National Development Company

BID BULLETIN NO. 1

Site Development Works for the NDC Industrial Estate Project Brgy. Langkaan, Dasmariñas, Cavite

3. Pump Complex No. 3 Genset to Deepwell No. 8 (Item R of BOQ)

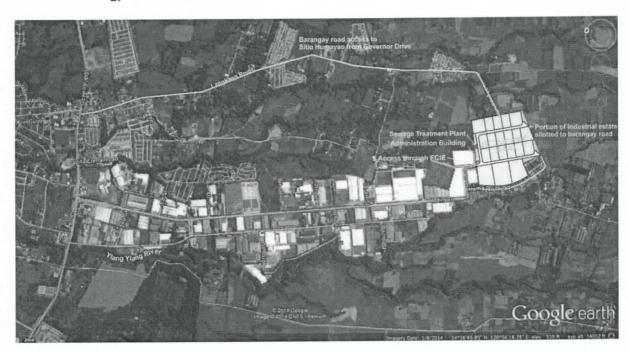
NDCIE water supply will be sourced from Phase 3. At least one deepwell shall be connected to the generator to supply water during power outages. The existing connection for Phase 3 is grounded. This shall be replaced with new XLPE cable as shown on the plan.

It is noted that the existing generator is **Cummins** brand. The FCIE Association recommends to use these brands for maintenance convenience.
